SERVICE LETTER

SKI SERVICE LETTER NO. 1

Subject: **INSPECTION OF SKI YOKE ARM**

Models Affected: **MODEL 3000 SKIS**

F3099-2 REINFORCED YOKE ARM

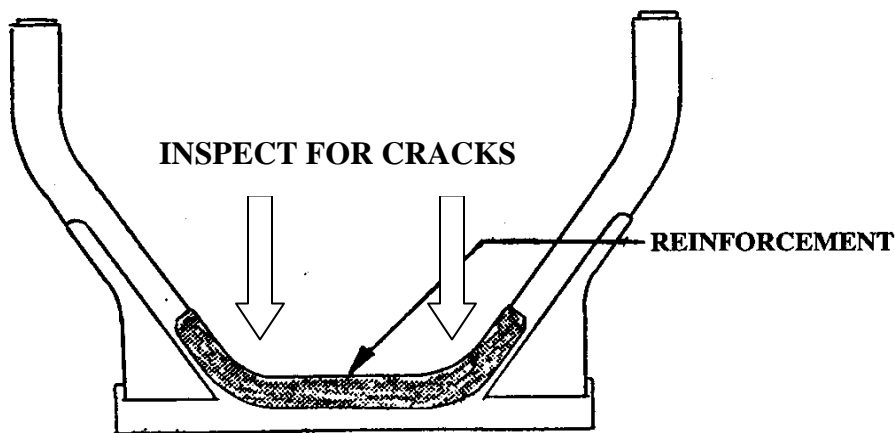
The purpose of this letter is to inform owners of Fli-Lite Skis to inspect the yoke arm in the areas noted on the sketch below. The yoke arm Fli-Lite p/n D-3099-1 (one rod-end bearing) and D-3099-2 (2 rod-end bearings) is the part affected.

Visually inspect the yoke arm every 25 of flight time for possible cracks in the areas noted.

If yoke arm re-enforcement (F3099-2) is installed with the gusset as shown in the sketch below, the inspection is not required.

If cracks are found, replace the yoke arm with re-enforced yoke arm p/n F3099-2.

Since this yoke arm is heat-treated, no field repair should be attempted.
